## PUBLIC WORKS Engineering

The Specification Review Committee recommends and asks the Public Works Deputy Director to approve the following:

1. Approve Modification to Standard Drawing 768 - Standard Recessed Curb Inlet.

STD. 768

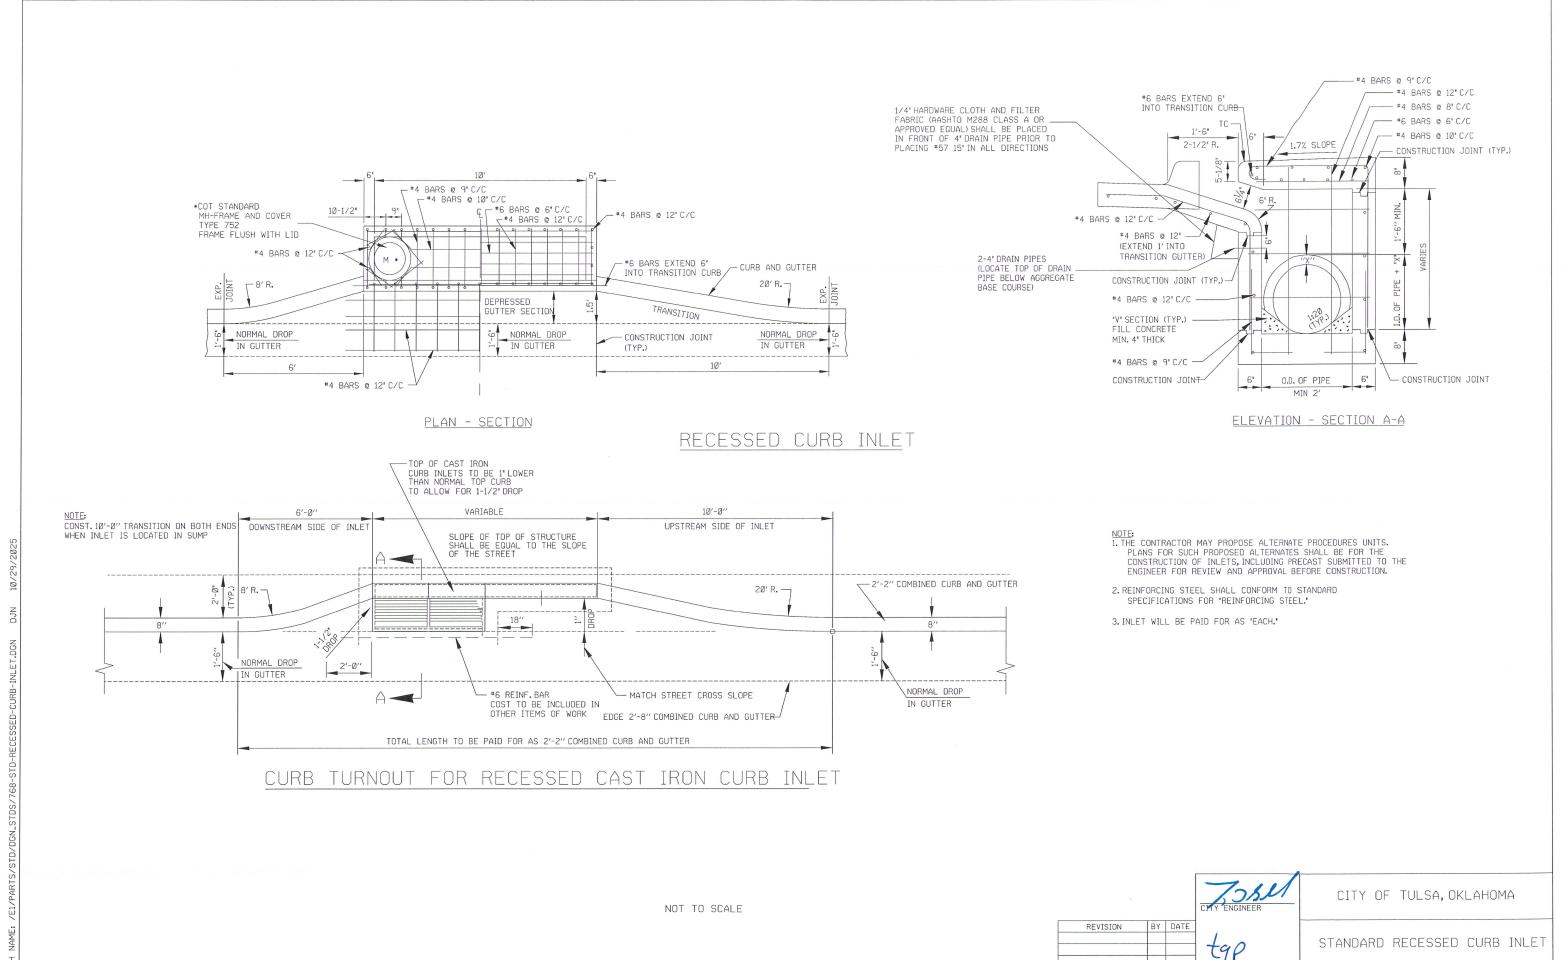
Summary of change: To add the under drain and setting the dimension for the gutter as 18".
